Subject Addendum to Work Plan for Historical Water Supply Well Reconnaissance – Well #1; Area 1A, Topock Compressor Station, Needles, California

Date 06 October, 2022

DATE: September 12, 2022

**SUBJECT: Work Plan for Historical Water Supply Well Reconnaissance
Well #1; Area 1A, Topock Compressor Station, Needles, California
(EPA ID NO. CAT080011729)**

FIGURE 2
Well #1 Historic Map Overlays
 Historical Water Supply Well Reconnaissance
 Pacific Gas and Electric Company Topock Compressor
 Station, Needles, California

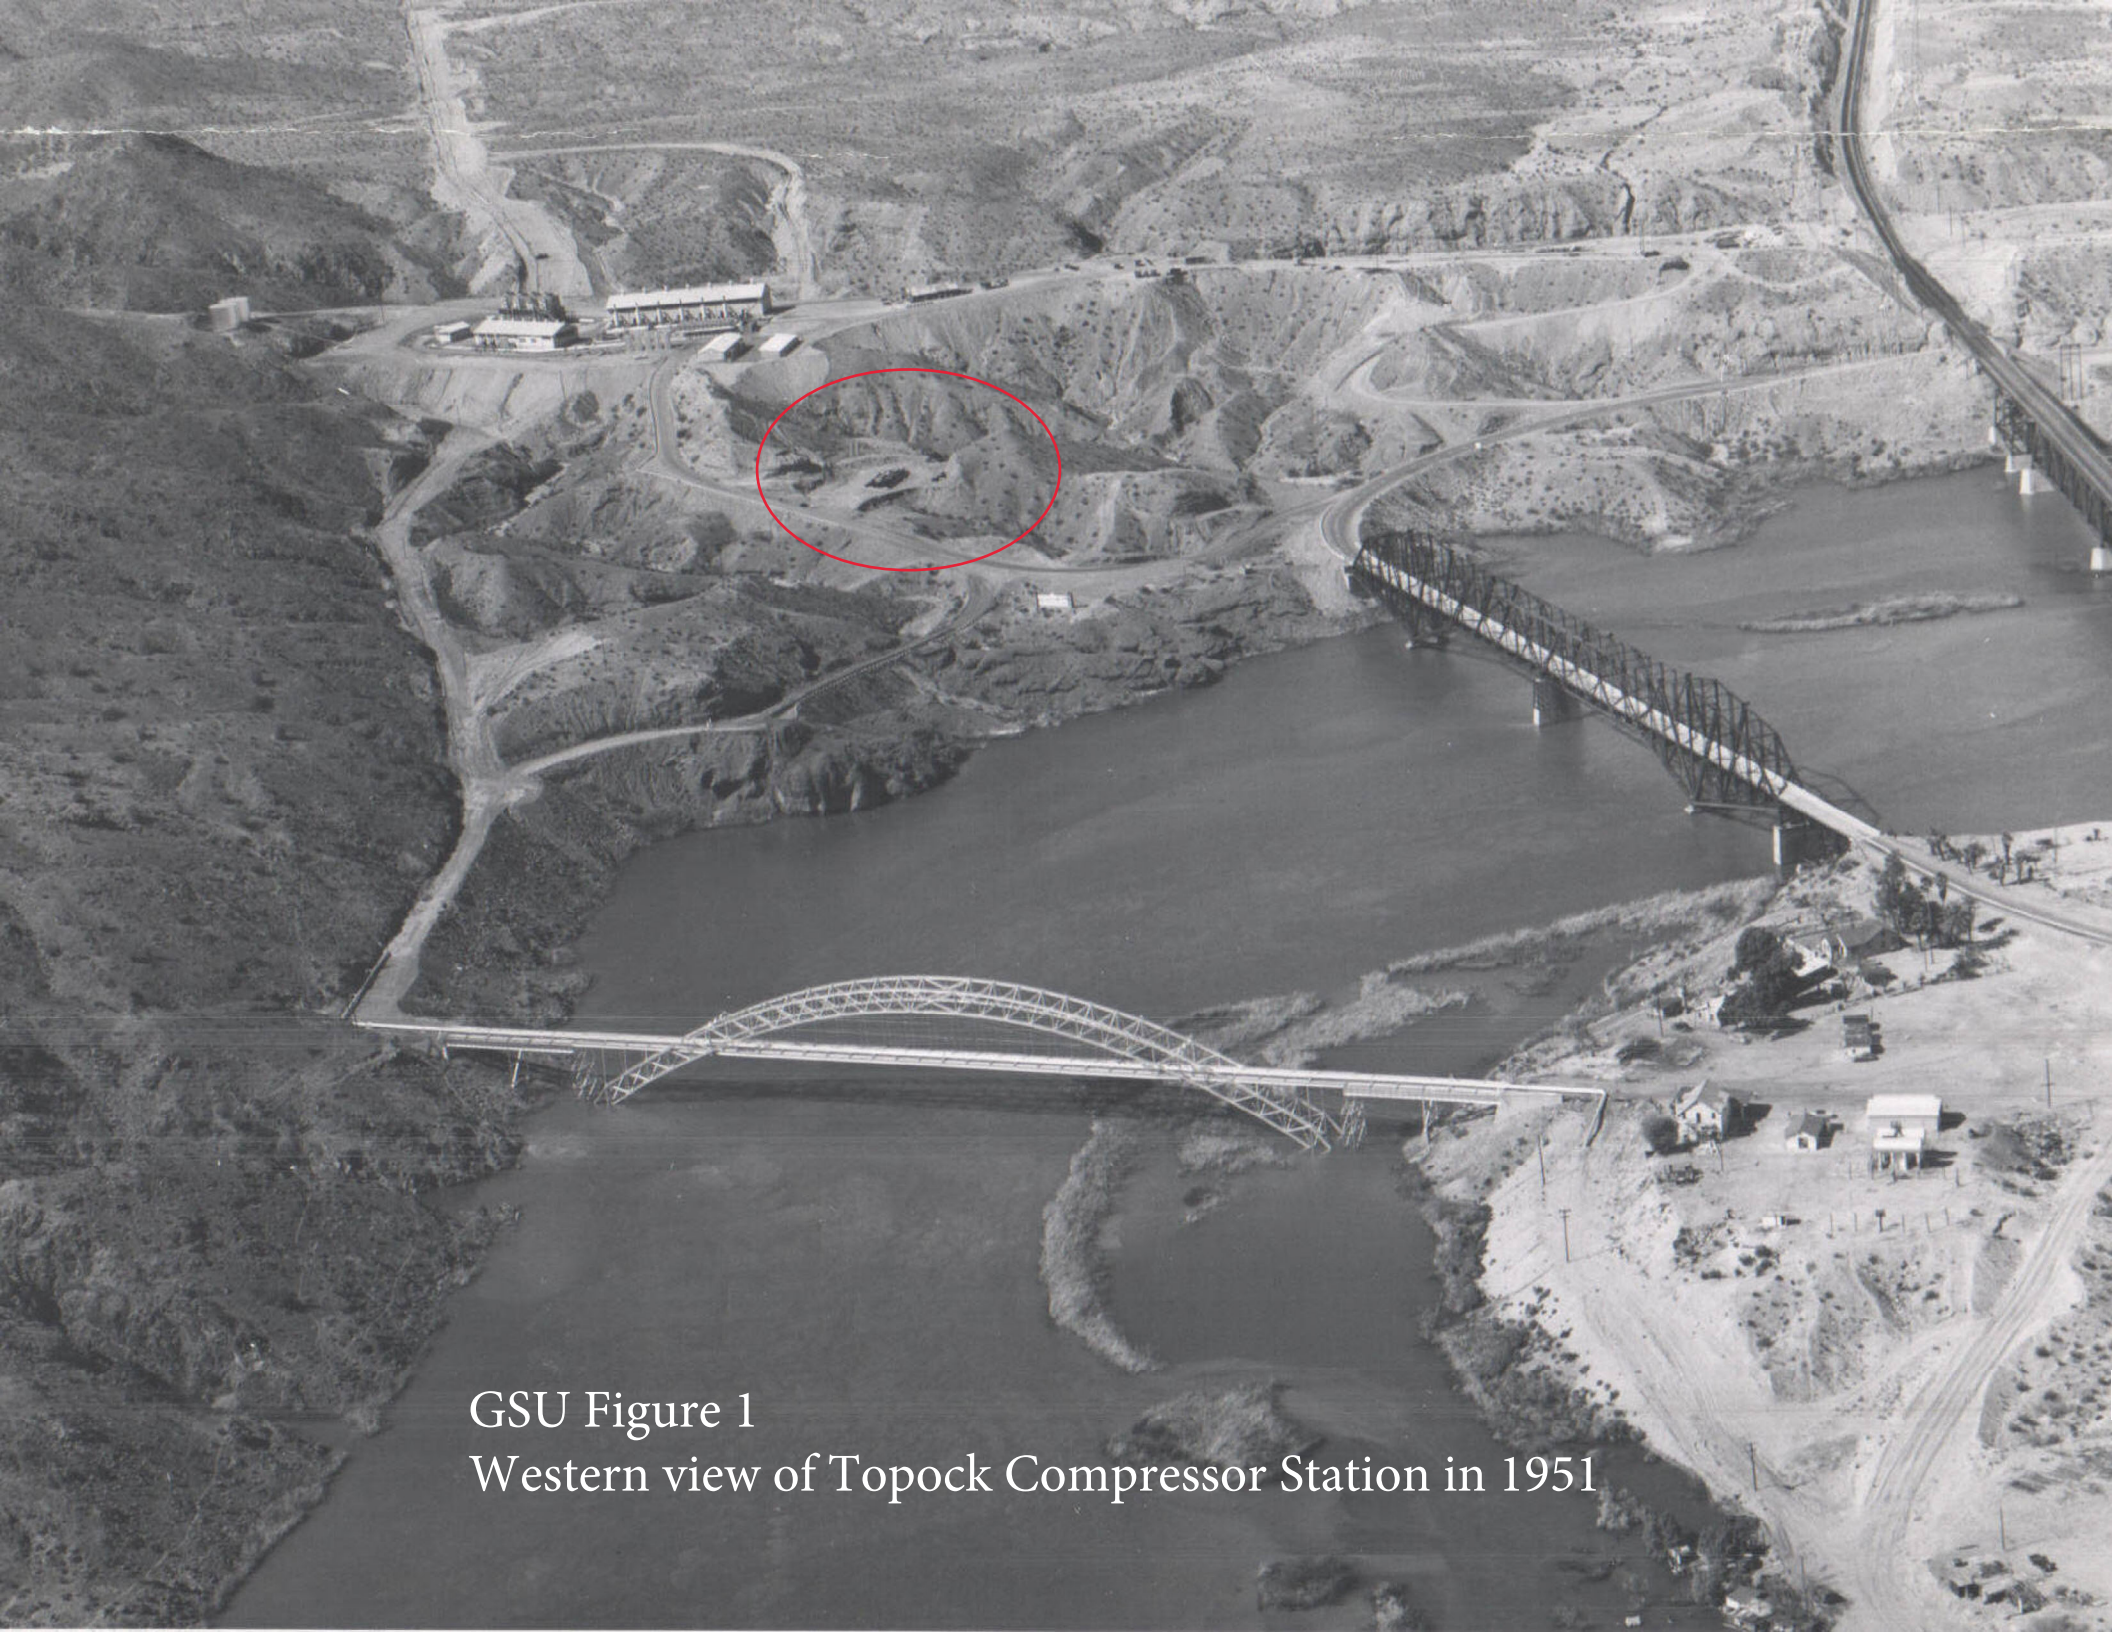
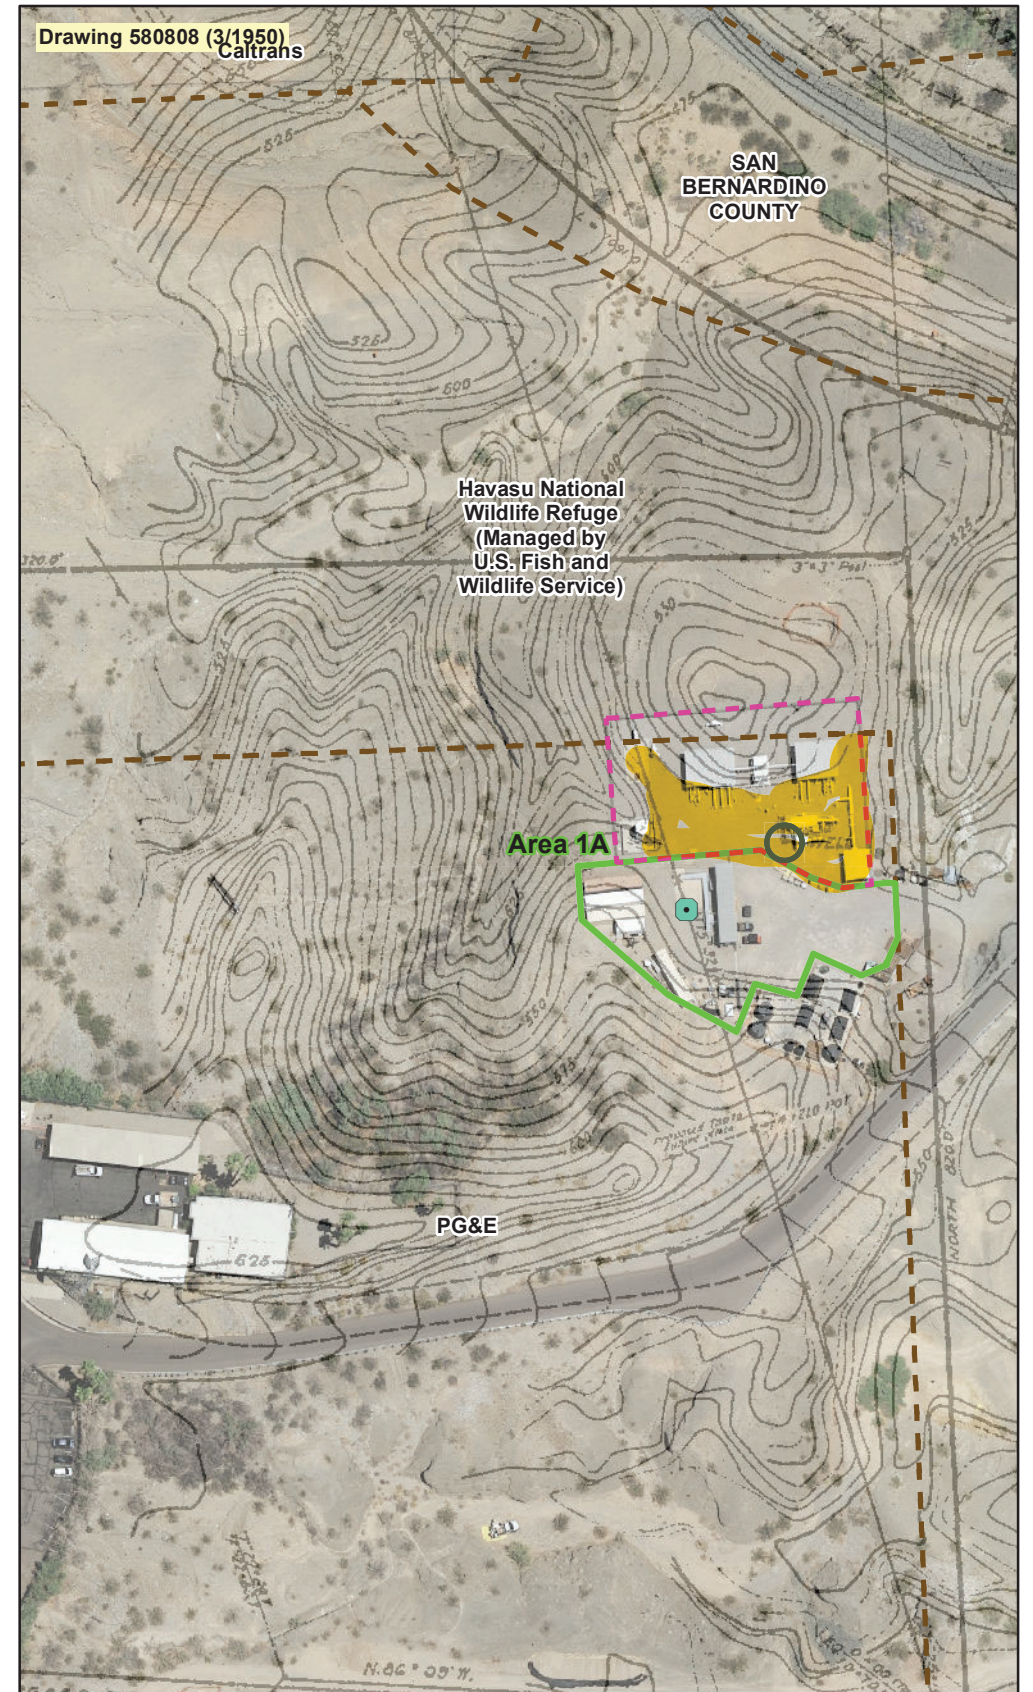
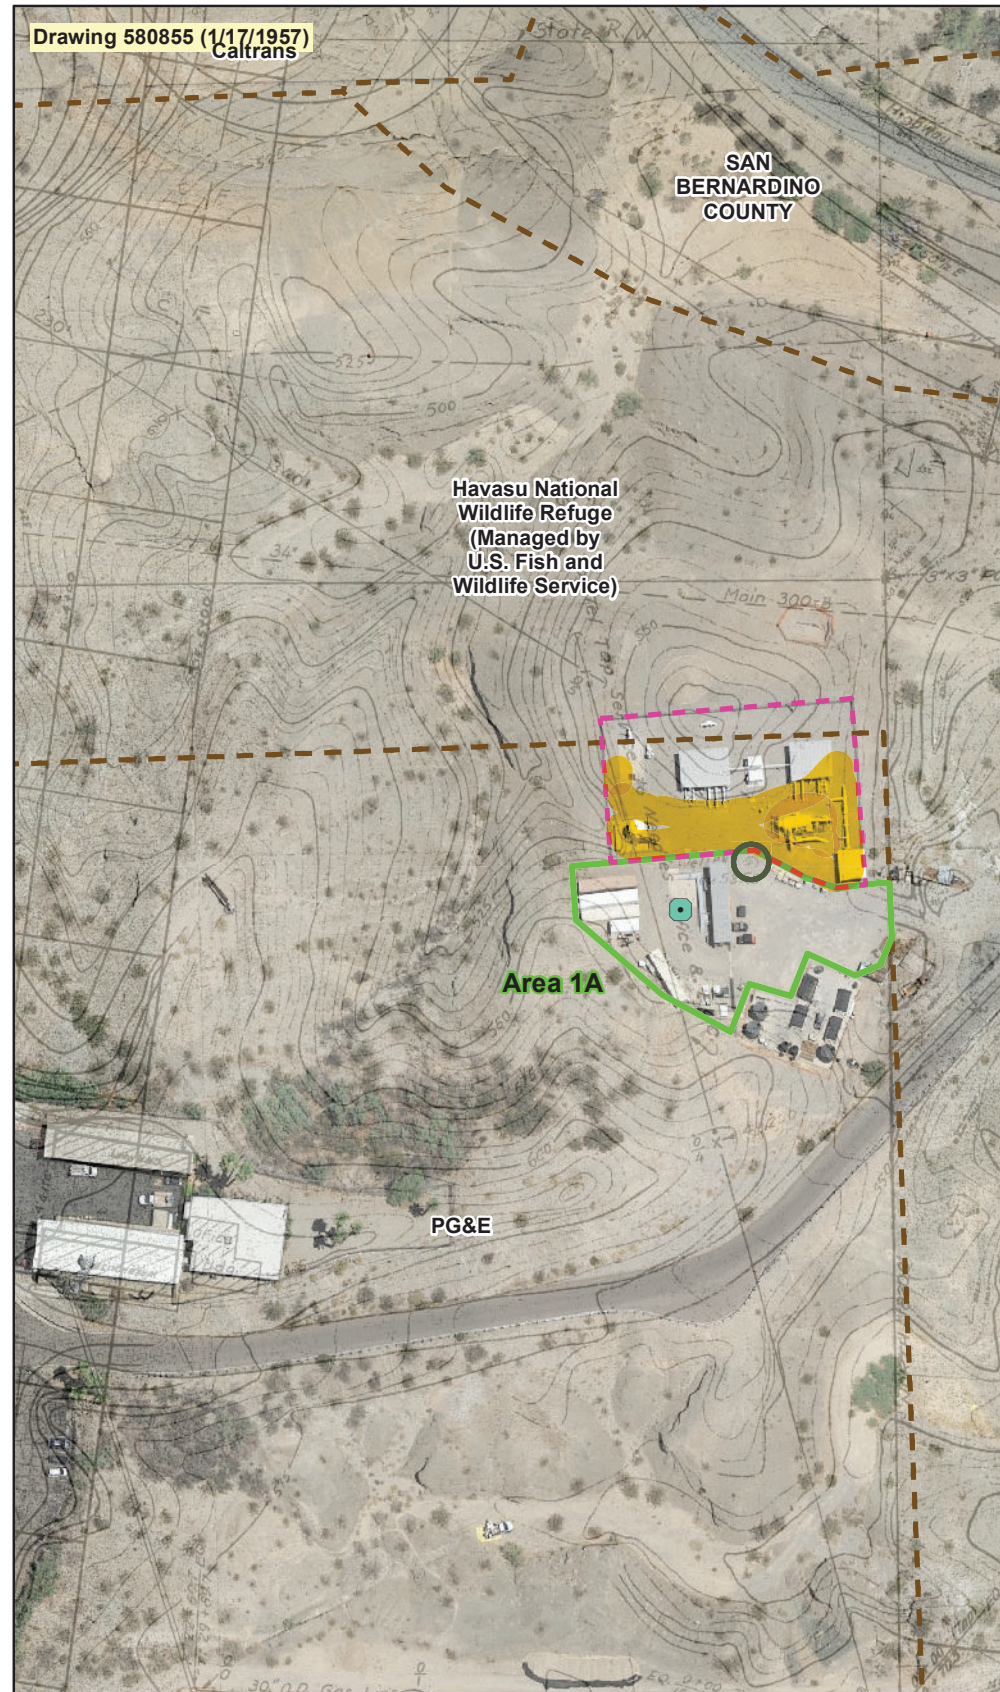
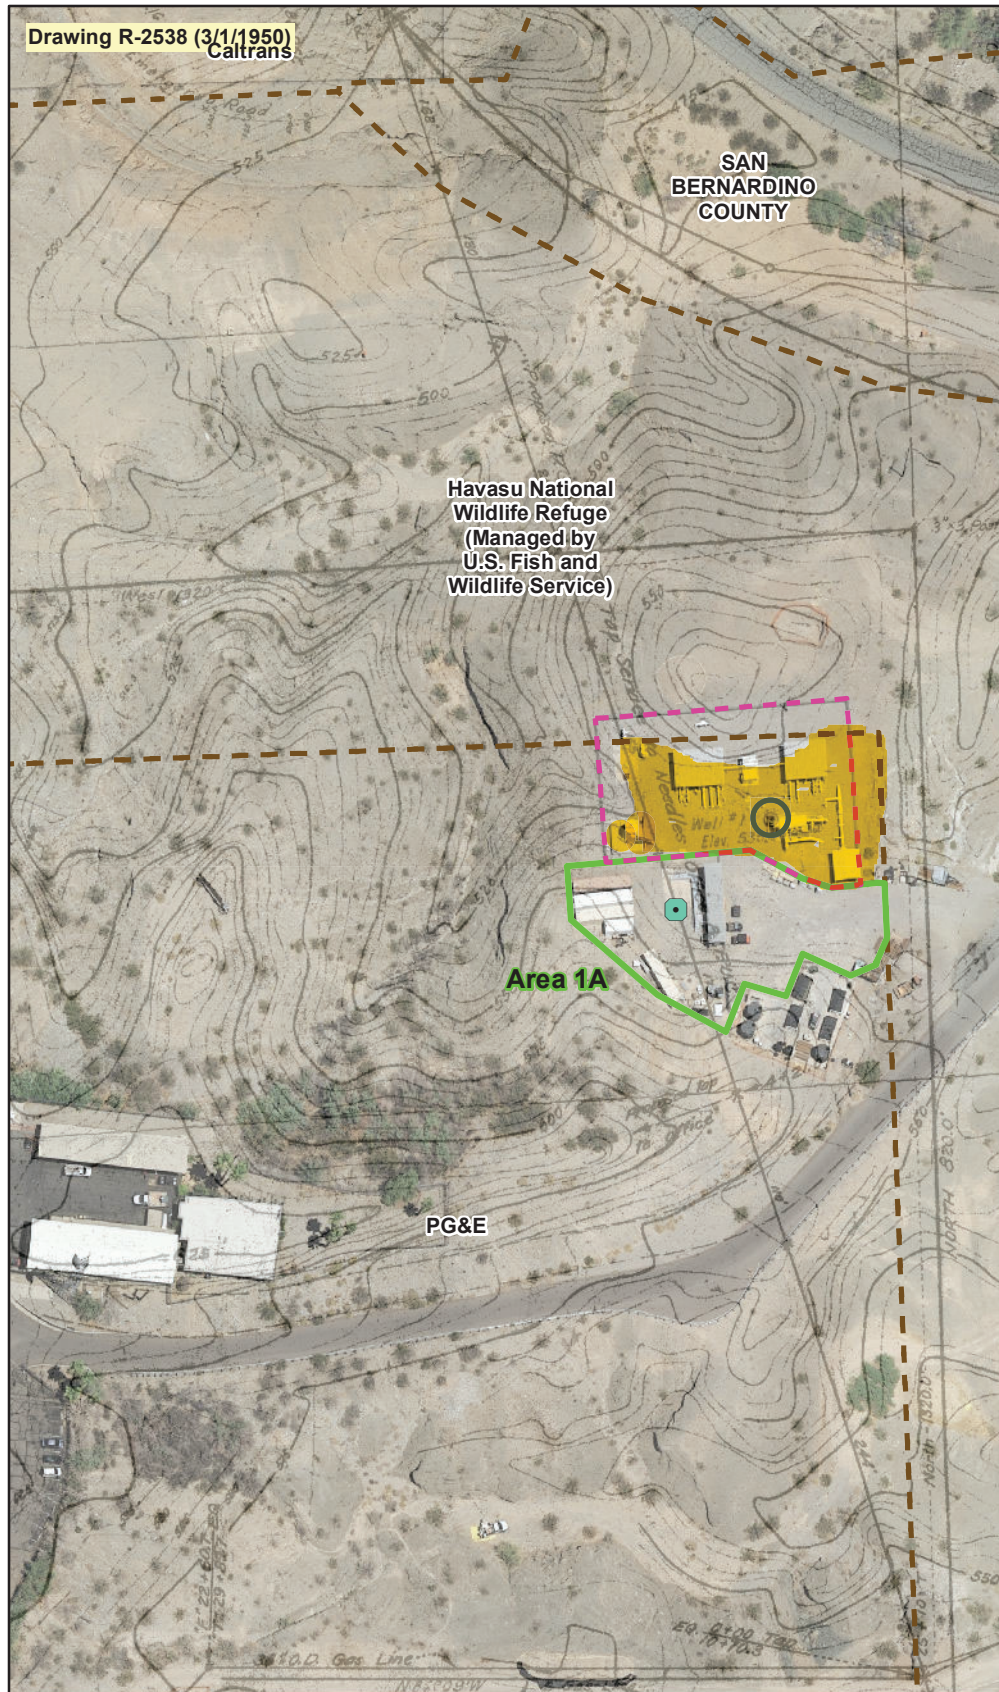
2. Proposed Survey Area 1A, Paragraph 1, Page 1: The Proposed Survey Area (Area 1A) to be evaluated is identified on Figures 1 and 2 of the Work Plan and excludes the Transwestern area. The Transwestern area is referred to as the "Transwestern Disturbed Area" on Figures 1 and 2. It should be noted that both the Transwestern and Area 1A areas are quite disturbed and both occur due to significant earthwork including removal of prominent hills. While Attachment 1, prepared by DTSC's GSU, estimates that Well #1 is outside the Transwestern fence line, Figure 2 of the Work Plan (Attachment 2) shows that Well #1 plots within or adjacent to the Transwestern fence line. Therefore, geophysical surveys should also include the area within the Transwestern fence. GSU Figure 1 shows the station in 1951. The

Transwestern and Area 1A area can be seen with grading that has occurred on the southern portion of the bench similar to Figure 2 Work Plan drawings. Figure 2 drawings and the 1951 aerial photograph also shows the large hill on the Transwestern Bench area that was later removed to construct the Transwestern facility as can be seen in the October 2006 aerial (GSU Figure 2). The yellow highlighted area on Attachment 2 is supposed to represent the southern flat area within the Transwestern yard that would have been available to drill a well circa 1950.

4. Proposed Survey Area 1A, Page 2: The section states, *“A surface feature found in June 2022 is depicted in Figure 2 and is located within the proposed survey area. The feature has been described as a metal casing estimated to be about 16 inches in diameter with a cement apron around the outside and containing compacted soil. The feature will be investigated in the survey.”* It is requested that this feature be addressed immediately and examined (e.g., potholed) and potentially removed if it is not a well as part of groundwater remedy preparation. If a well is found, then the Work Plan should be significantly modified to gather information to aid in well decommissioning or rehabilitation. If the feature is not a well, then it could be removed and provide less interference for the proposed geophysical surveys.

Specific Comment 2: This Work Plan excludes the area within the Transwestern metering station fence line as it is an active facility that PG&E does not control. This comment is noted, and should implementation of this Work Plan not yield the location of Well #1 (exploratory well), the area identified by DTSC will be addressed as part of the April 25, 2019 work plan.

Specific Comment 4: The initial survey outlined in the Work Plan will include assessment of the surface feature and the results will inform the understanding as to whether the feature is shallow or extends tens of feet into the subsurface (the latter case being more indicative of a well). If the feature is determined to be shallow it will be addressed as part of the preparation for the groundwater remedy and if it is determined to potentially be a well, it will be evaluated as part of a subsequent step in the implementation of this work plan.
